## Staff Briefing Papers

Docket No. **E-999/CI-16-521**  
**E-999/CI-01-1023**

**In the Matter of Updating the Generic Standards for the Interconnection and Operation of Distributed Generation Facilities Established under Minn. Stat. 216B.1611**

Issues Should the Commission approve, modify or remand to the Technical Subgroup the proposed statewide Minnesota Distributed Energy Resource Technical Interconnection and Interoperability Requirements (TIIR) and associated implementation plan?

**Figure 1: Xcel Proposal**

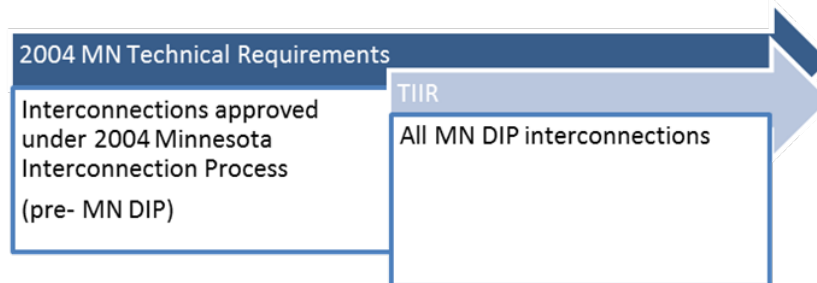
Xcel's proposed revision to the definition of Minnesota (MN) Technical Requirements would require interconnections that applied beginning in June 2019 to comply with the TIIR. Staff notes that the TIIR recognizes IEEE 1547-2018, but it also includes UL 1741 in its References; and states: "At the time an interconnection application is submitted, the Area EPS Operator and the DER Operator shall use the most recent applicable technical reference."<sup>26</sup> Staff is unclear if this Draft TIIR language without MN DIP Att. 4 is sufficient to recognize some UL 1741 certified inverters installed in this interim period may be able to comply with some, but not all of IEEE 1547-2018.<sup>27</sup>

Staff notes it may be appropriate to recognize that these "applications subject to the MN DIP" approved in the interim of equipment certified to IEEE 1547-2018 may not be able to comply with the TIIR when IEEE 1547-2018 relevant sections go into effect. Below are two visuals that shows staff's understanding of Xcel Energy's proposal and, secondly, staff's understanding of the role of

**Figure 2: Staff Understanding of MN DIP Attachment 4**

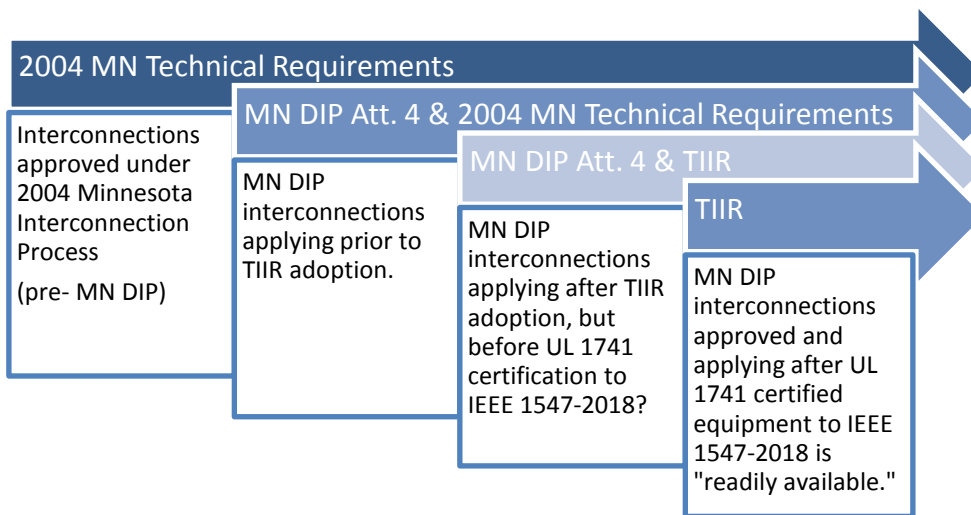
Staff interprets the above interim language in the MN DIP to grant the Commission flexibility in determining when the TIIR goes into effect –both interim and full - and which interconnections under the MN DIP will be held to the 2004 Minnesota Technical Requirements and MN DIP Att. 4 compared to which will be required to comply with the TIIR – either fully or with support of the MN DIP Attachment 4.

Staff does not disagree with Xcel’s proposed modification to MN DIP Attachment 4; however, questions whether it is premature and if it could be done as part of the at least annual review envisioned by the Commission’s August 13, 2018 Order adopting the MN DIP.<sup>28</sup> MN DIP Att. 4 provides the references IREC and Fresh Energy flag need to be clear during this interim period; however, it does not go as far as making explicit which Draft TIIR Sections will go into effect only after equipment certified to IEEE 1547-2018 is “readily available” which they propose be outlined in a companion guidance document to be developed.
